**Project #20-010
Quayle Hollow Subdivision
Located at 1800 N 200 W**

Project Name: Quayle Hollow Subdivision
Proponent/Owner: Nic Porter / Quayle, Dean W & Luan W TRS
Project Address: Approximately 1800 N 200 W
Request: Subdivision Permit
Current Zoning: NR-6
Date of Hearing: February 27, 2020
Type of Action: Quasi-Judicial
Submitted By: Aaron Smith, Planner II

Staff recommends that the Planning Commission require a resubmittal of the Preliminary Plat that substantially complies with the Recommended Conditions of Approval and all applicable Logan City Subdivision standards prior to any Planning Commission action on a Subdivision Permit for Project #20-010, Quayle Hollow Subdivision, for 27 new building lots located at approximately 1800 N 200 W; TIN #04-080-0032.

**QUAYLE SUBDIVISION
PRELIMINARY PLAT
SECTION 21, TOWNSHIP 12 NORTH, RANGE 1 EAST**

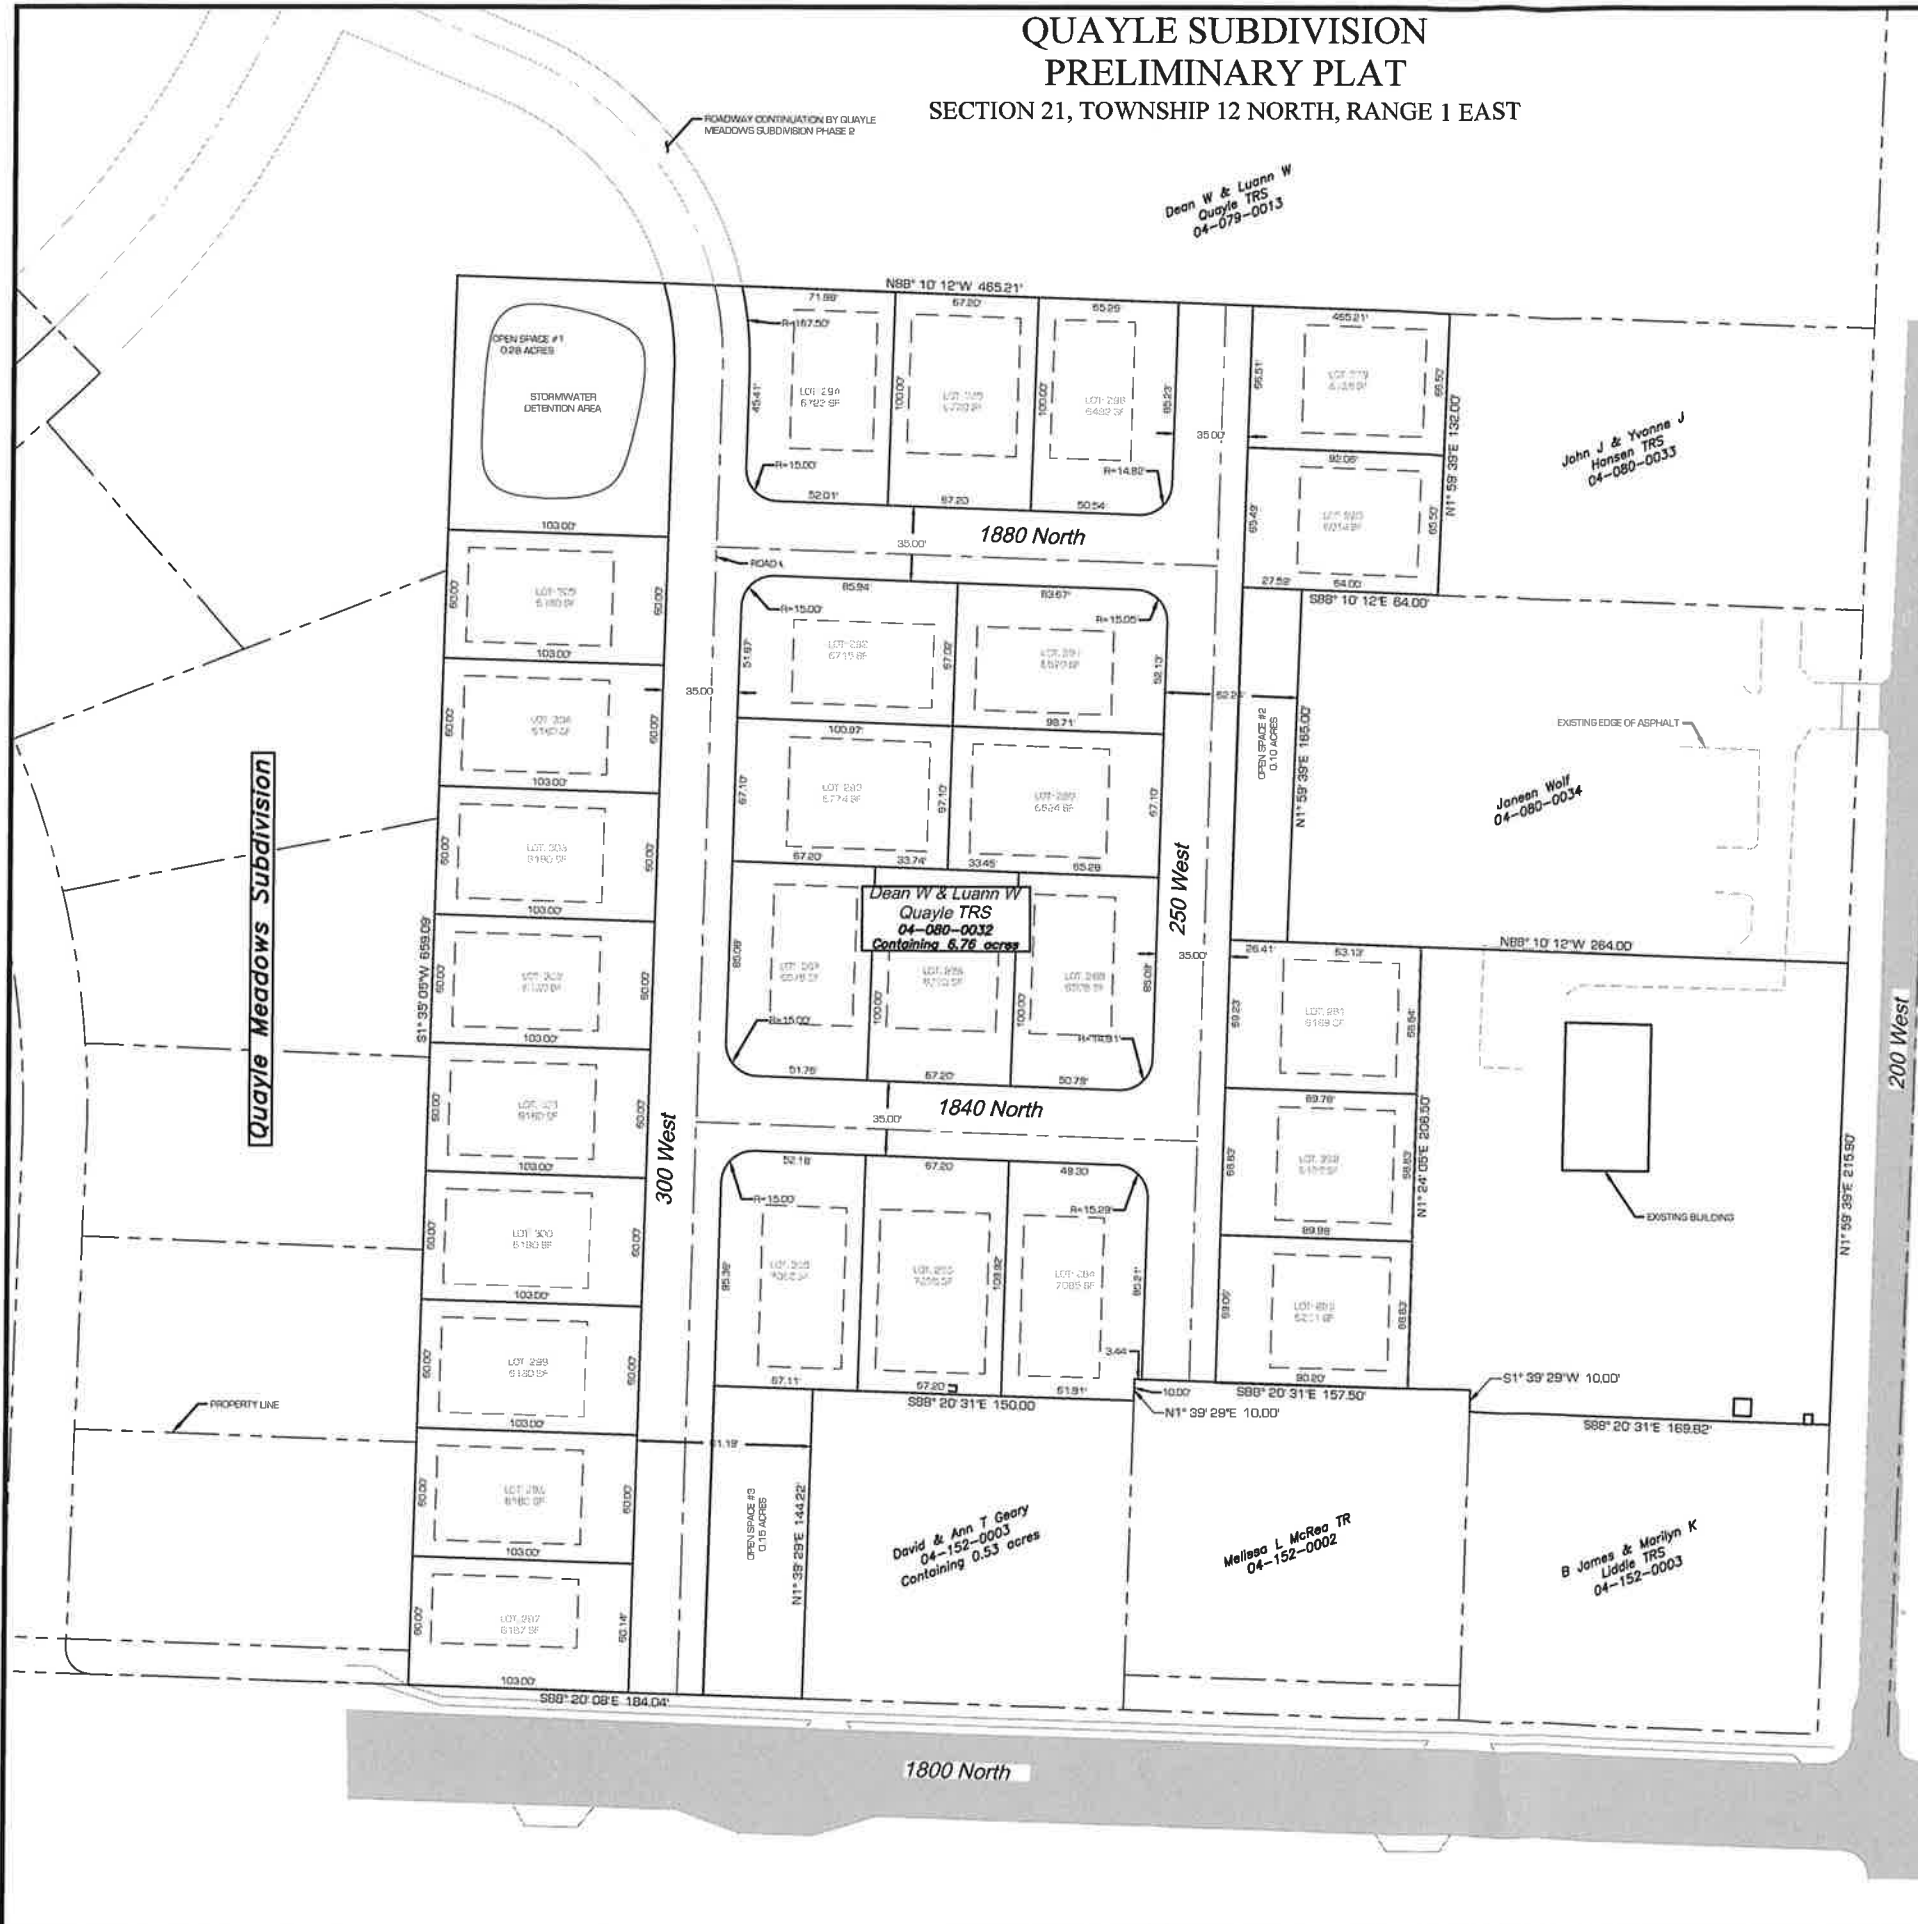
While the LDC does permit private roads, the code specifies that all privately owned streets shall be designed, built, and maintained to the same standard as public streets. Staff finds that the proposed private street cross-section is inadequate for the proposed development. The proposed street cross-section, while found in the City's engineer standards, is intended to be used for small subdivision, such as flag lots, that have only one street connection and 8 or less units. The proposed street cross-section lacks amenities that are expected for residential street in a subdivision of this size, such as on-street parking and sidewalks along both sides of the street. For residential blocks, as proposed in this subdivision, the Logan City engineering standards and Transportation Master Plan specify a 60' street cross-sections. The residential cross-section standard includes two 11.5' traffic lanes, on-street parking, and an 8' parkstrip and 4' sidewalk on both sides of the road.

300 W is considered a gridded street and is required to have a 66' public right-of-way. The 66' standard road width will accommodate additional on-street parking. Both the 66' and 60' street cross-sections have precedent in the neighborhood. The adjacent Quayle Meadow Subdivision was approved with a 66' right-of-way for 400 W, and 1950 N; and 60' right-of-way on all other residential streets. Street cross sections in Quayle Meadow include at least 5' of sidewalks and a 6' parkstrips along all streets. While variation in this cross-section may be permitted by the Planning Commission, it is staff's position that at a minimum on-street parking on one side of the road, and parkstrips and sidewalks on both sides of the road should be required to create a residential street that will support access and mobility for residents and provide parking for guests in the neighborhood. Staff recommends resubmittal of the Preliminary Plat that address the street cross-section changes.

The LDC requires 3 points of connection for subdivisions greater than 20 lots. The subdivision proposes 2 points of connection. The 300 W 1800 N connection is required to be aligned with Kensington Street in Yorkshire Village across 1800 North to prevent left turn hazards. The 300 N connection through the Quayle Meadow Subdivision does not align with any proposed street within the approved subdivision. Because subsequent phases of the Quayle Meadows Subdivision will have to be adjusted to accommodate the connection, the applicant needs to provide documentation from the property owner that indicates their willingness to amend the Quayle Meadow project.

The proposed subdivision includes two road stubs that could later be turned into connections at the north and south ends of 250 W; however, the connection to the north interferes with a proposed church on the original Quayle Meadows Subdivision, and the stub to south dead ends into a backyard of a single-family home. The LDC required that street stubs align with existing, proposed, or planned streets outside of the development. Neither of the proposed stubs meet this alignment requirement. A subdivision can be approved with less than 3 connections where

3. All street cross-sections must provide on-street parking, and a minimum 5' sidewalk and 6' parkstrip on both sides of the street.
4. Street trees shall be provided on both sides of all streets every 30' on center.

5. Three (3) street connections shall be provided. A street stub may be provided to meet one of the connection requirements if it aligns with an existing, proposed, or planned street outside the development.

- a. **Fire —contact 716-9515**
 - i. Place hydrants within 600 feet of all buildable area of all lots.
 - b. **Engineering —contact 716-9153**
 - i. 300 West lays out as a gridded street per City Transportation Master Plan and as such shall be a 66' public road connecting to 1800 North. All other roads shall be 60' unless approved otherwise by planning commission.

- ii. Align 300 West with access (Kensington Street) in Yorkshire Village on 1800 North.
- iii. Provide water shares or an in-leu fee for increase water demand on City system.

PRIVATE STREET
CROSS SECTION

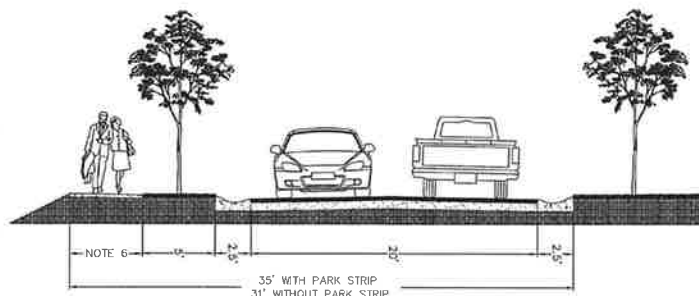
The proposed subdivision includes private streets. The primary street that connects through the subdivision, 300 W, connects to 1800 N to the south and the Quayle Meadows subdivision to the north. The subdivision includes additional streets 1880 N, 1840 N, and 250 W. All of the proposed private streets have 35' cross-sections based on the Private Street Cross Section found in the Logan City engineering standards. The proposed street has a 20' pavement width, a 2.5' mountable curb on both sides, and a 5' parkstrip and 5' sidewalk on one side.
